Process Sheet

Customer	: CU-DAR001	Dart Helicopters Services	Drawing Name	: HELI ACCESS STEP EXT HIGH GEAR
Job Number	: 32508			
Estimate Number	: 12874			
P.O. Number	: N/A		Part Number	: D205633025
This Issue	: 5/23/2007	S.O. No. : N/A	Drawing Number	: DSI 9300 REV B
Prsht Rev.	: NC		Project Number	: N/A
First Issue	: N/A	Type : LARGE FAB ASSY	Drawing Revision	: B
Previous Run	: N/A		Material	: N/A
Written By	:		Due Date	: 6/10/2007
Checked & Approved By	:		Qty:	2 Um: Each
Comment	:			
	:	Est Rev: B		
	:	Added D3165-1		
	:	KJ/JLM		
	:	05-09-09

DART SERVICE INSTRUCTION

TO AMEND INSTALLATION INSTRUCTIONS IIN-D205-633 REV. A

INSTALLATION OF D205-633-021/-022/-023/-024/-025/-026

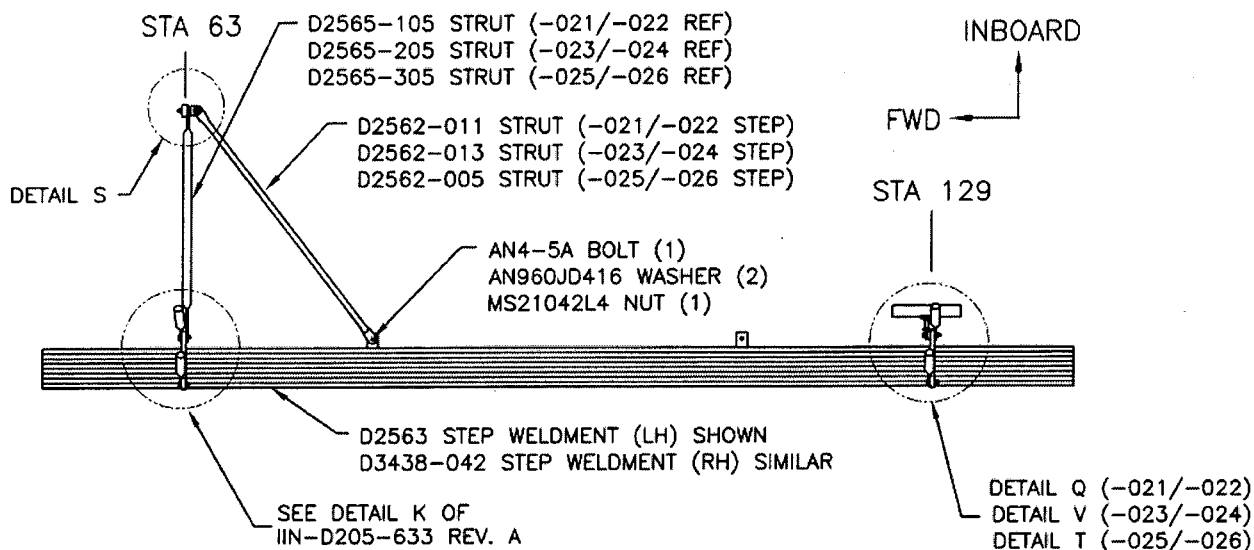
INSTALL D205-633-021/-022 AS PER THE D205-633-011 STEP OF INSTALLATION INSTRUCTIONS IIN-D205-633 REV.A, EXCEPT REPLACE D2565-111 STRUT WITH THE D3437-041 AFT STRUT ASS'Y, REMOVE D2562-001 STRUT, INSTALL D2562-011 STRUT AS SHOWN.

INSTALL D205-633-023/-024 AS PER THE D205-633-013 STEP OF INSTALLATION INSTRUCTIONS IIN-D205-633 REV.A, EXCEPT REPLACE D2565-211 STRUT WITH THE D3437-043 AFT STRUT ASS'Y, REMOVE D2562-003 STRUT, INSTALL D2562-013 STRUT AS SHOWN.

INSTALL D205-633-025/-026 AS PER THE D205-633-015 STEP OF INSTALLATION INSTRUCTIONS IIN-D205-633 REV.A, EXCEPT REPLACE D3165-1 SUPPORT ARM WITH THE D3437-045 AFT STRUT ASS'Y AS SHOWN.

SHOP COPY
RETURN TO
ENGINEERING
(-021/-022 STEP)
UNCONTROLLED COPY
SUBJECT TO AMENDMENT
WITHOUT NOTICE
WORK ORDER
NO. **32508**
VIEW R-R
NOT TO SCALE

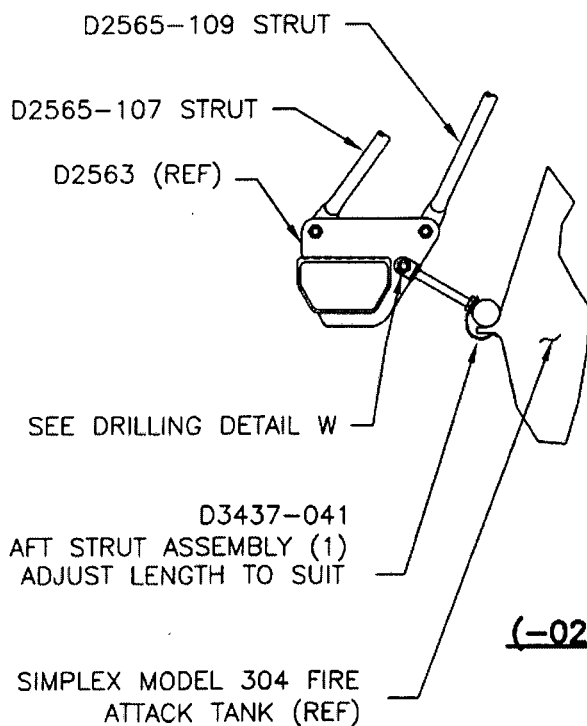
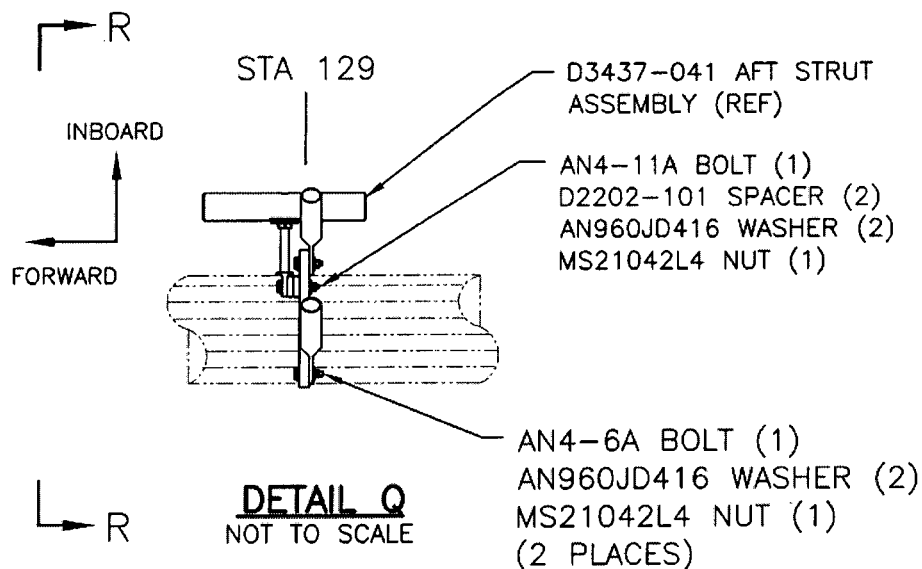
DETAIL W
DRILL $\varnothing 0.257$ THRU,
TOUCH UP WITH
ALODINE 1200 OR 1201
PER MIL-C-5541 AS SHOWN
